ADDENDUM NO. 1

PROJECT NAME: Nebraska Soccer & Tennis Complex
UNL PROJECT NUMBER: C909P101
BID INVITATION NUMBER: 2257-13-7214

CONSULTANT: Olsson Associates, Inc.
ADDRESS: 1111 Lincoln Mall, Suite 111, Lincoln, NE 68508

DATE OF ISSUANCE: Friday, October 18, 2013
DATE OF BID OPENING: Thursday, October 24, 2013

DEMOLITION PLAN - DRAWING SHEET NO. 1 OF 7

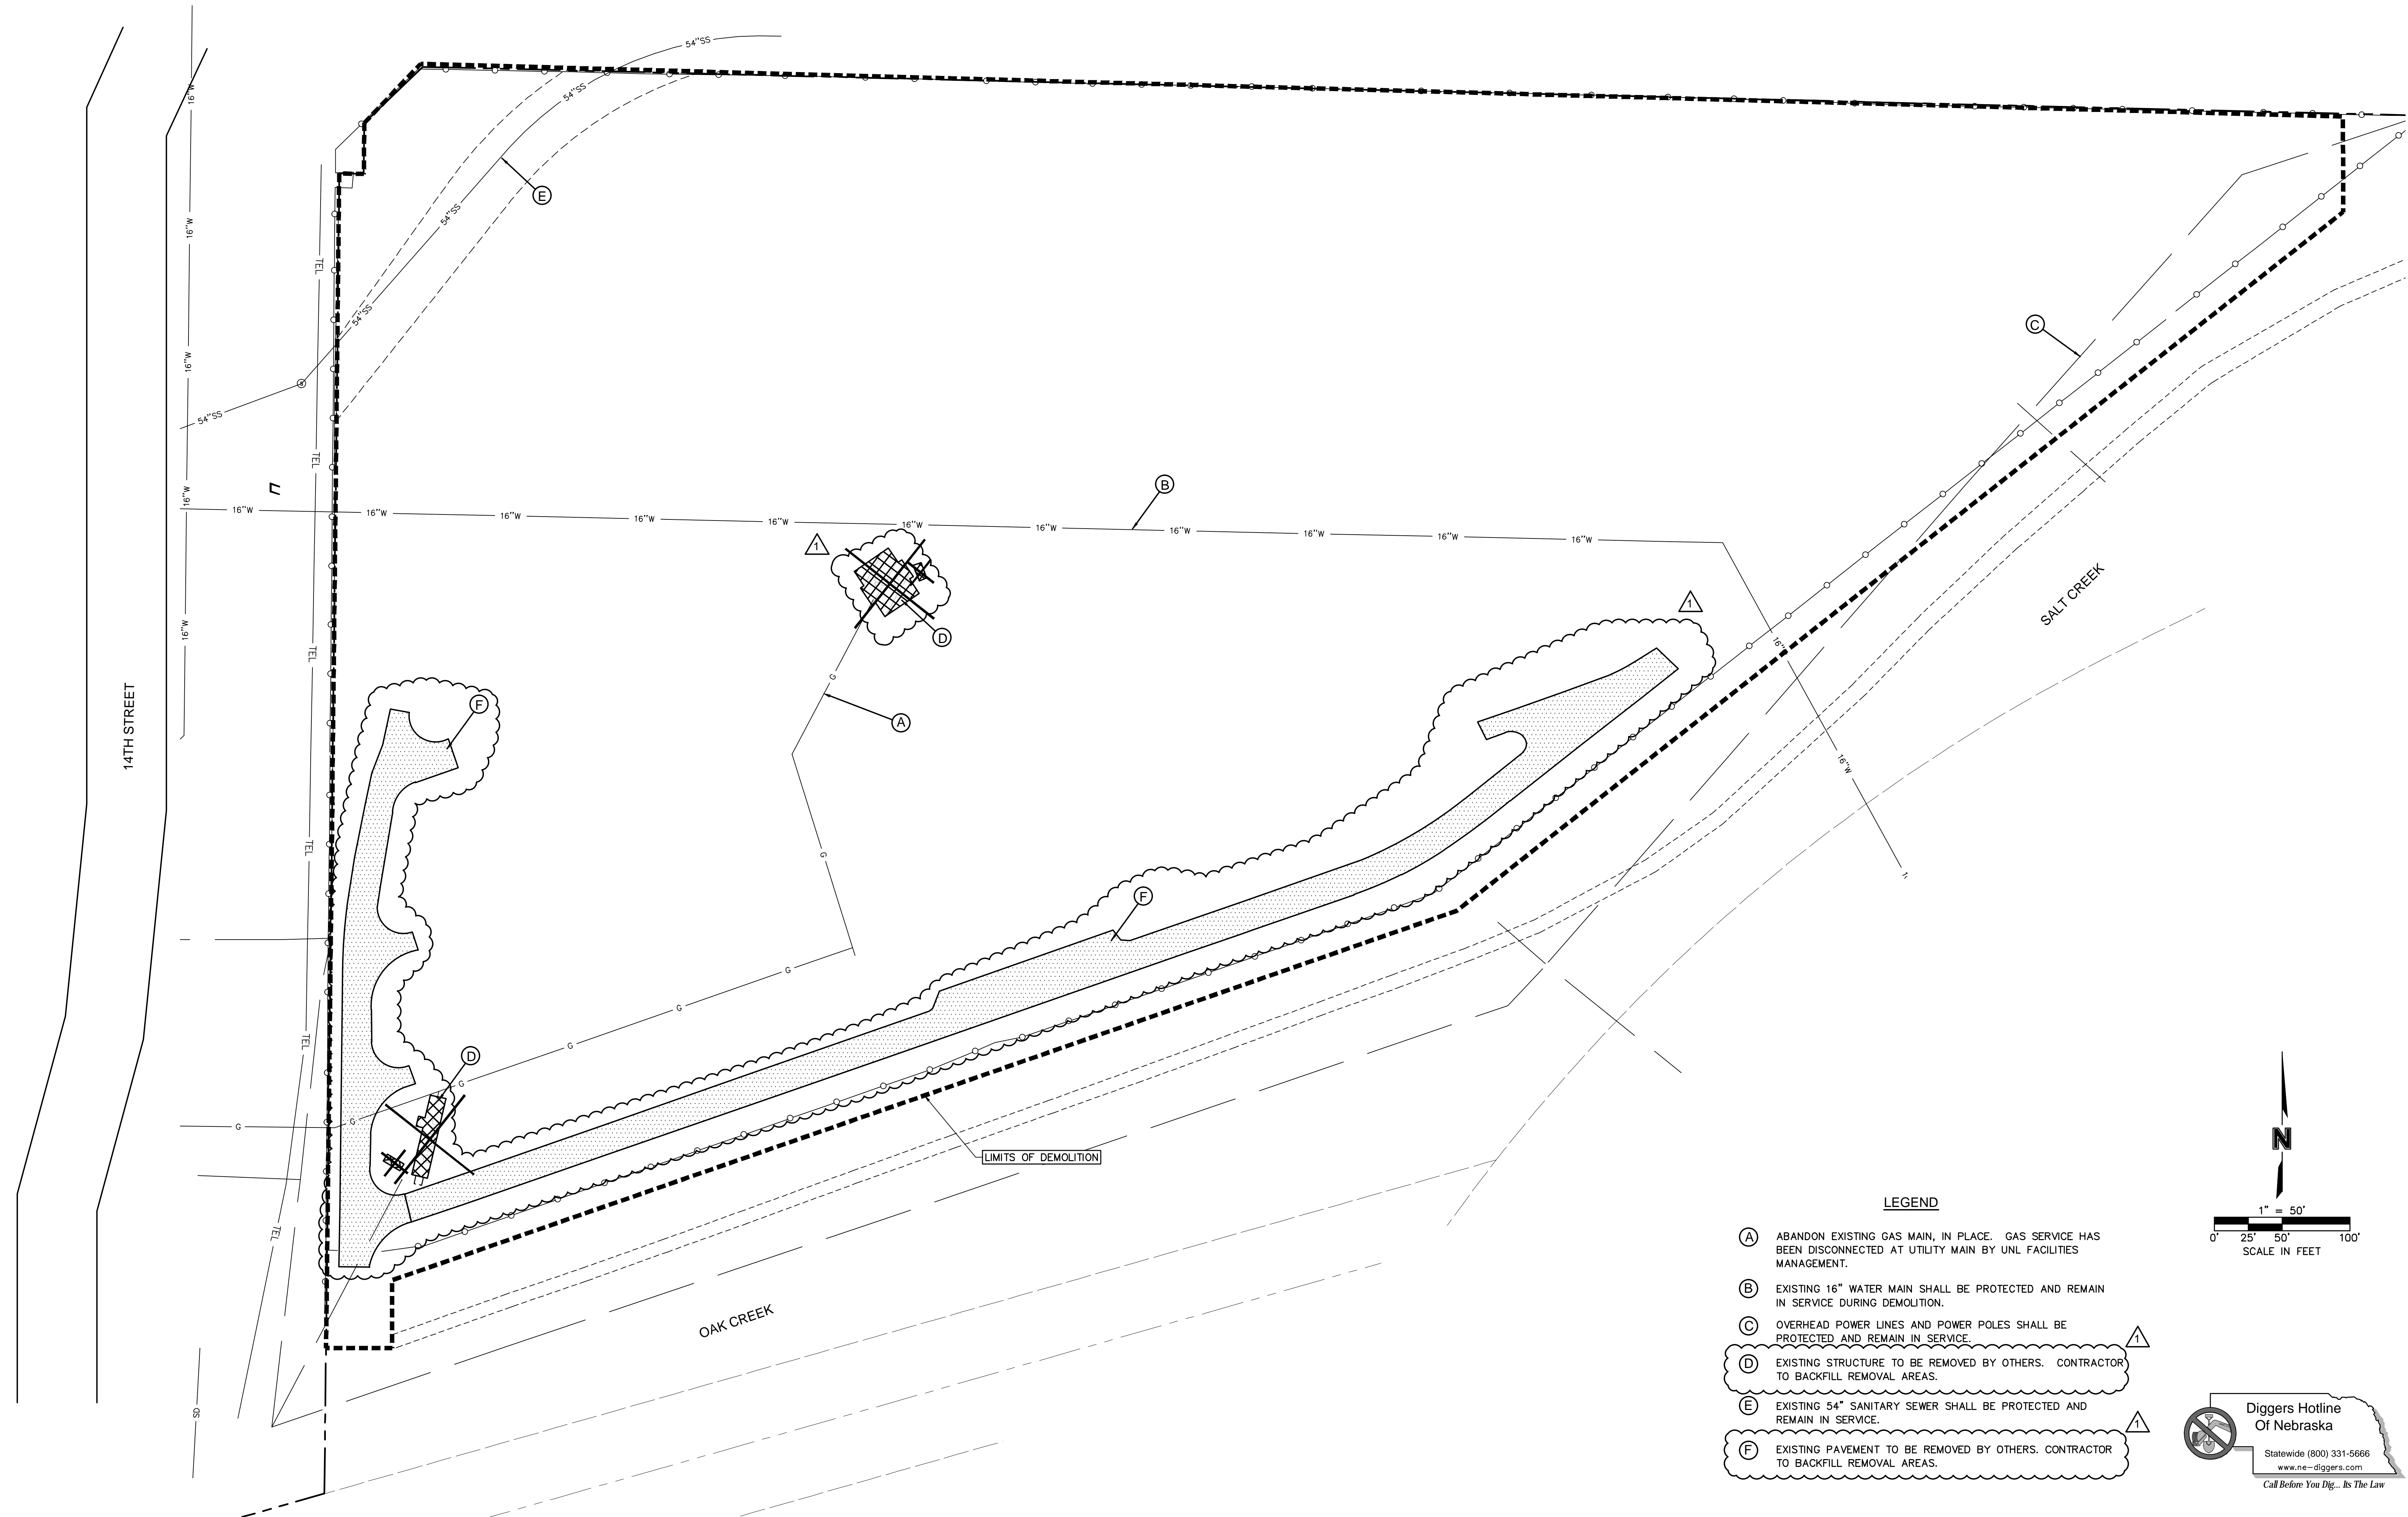
REV. NO.	DATE	REVISIONS DESCRIPTION
1	10/17/2013	BUILDING DEMO NOTES

PHASING PLAN - DRAWING SHEET NO. 2 OF 7

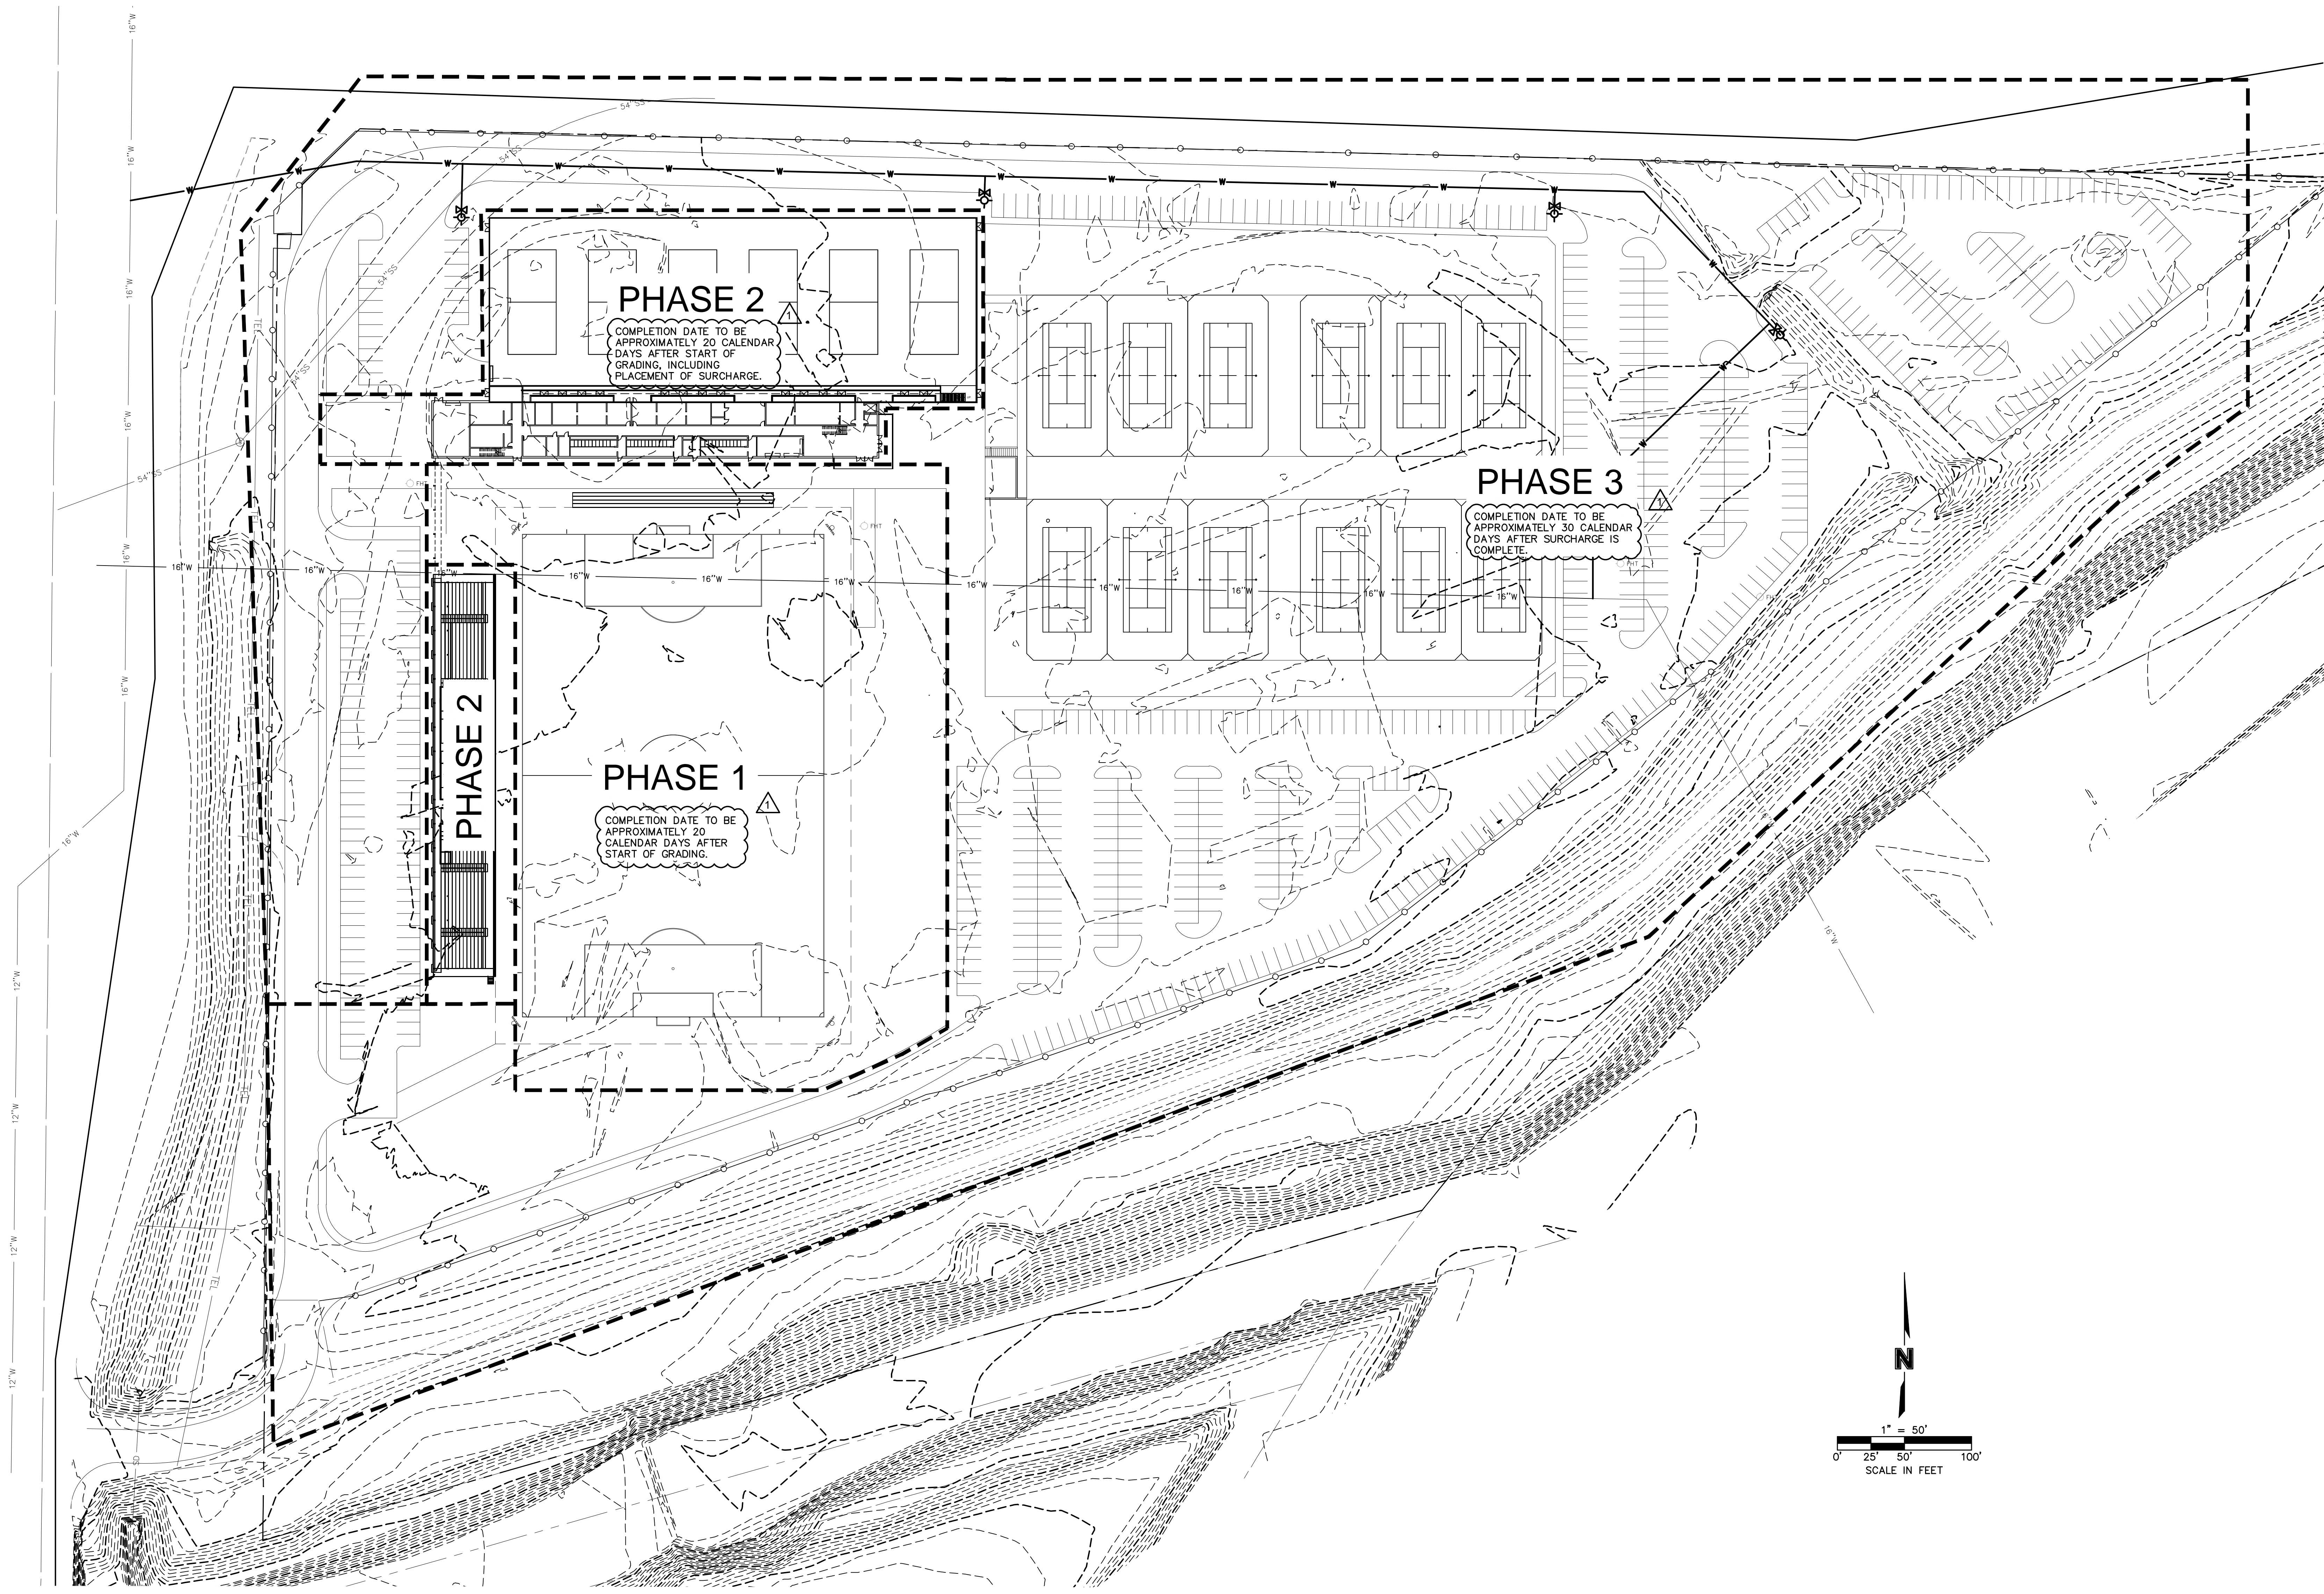
REV. NO.	DATE	REVISIONS DESCRIPTION
1	10.17.2013	SCHEDULING

SHEET
 3 of 7

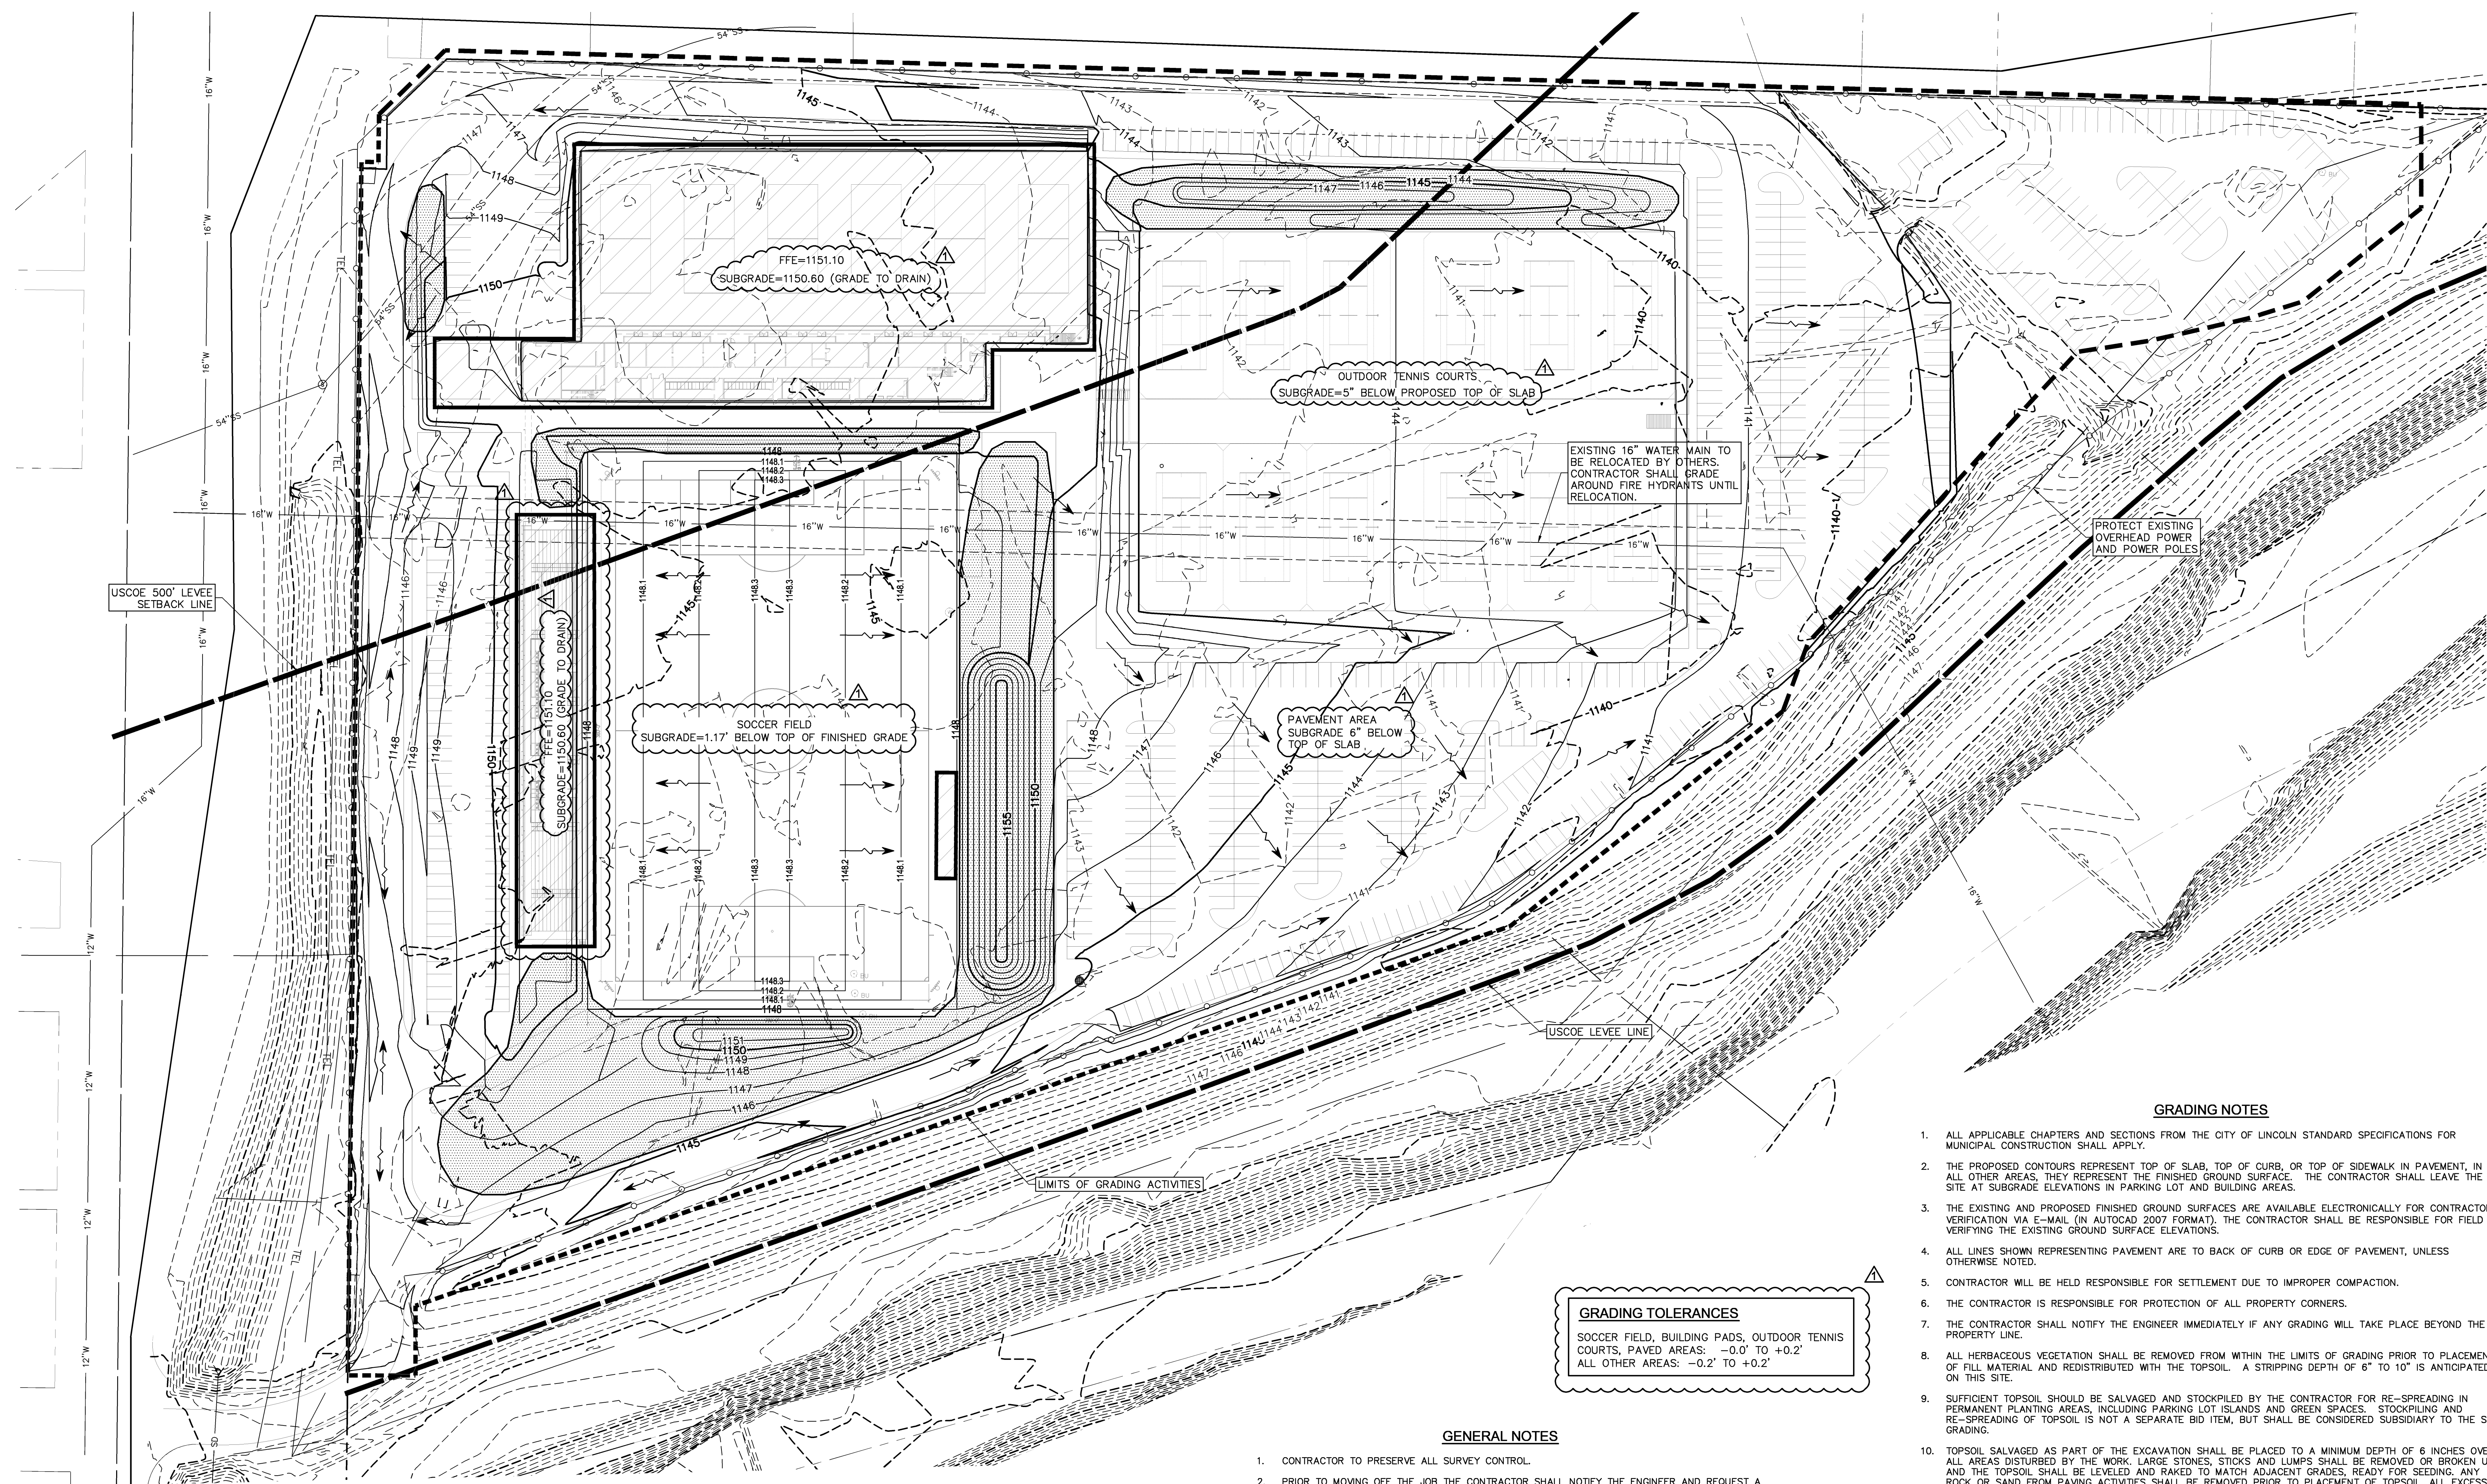
REV. NO.	DATE	REVISIONS DESCRIPTION
1	10.18.2013	Soccer Field Elevation, Subgrade, Topsoil Areas
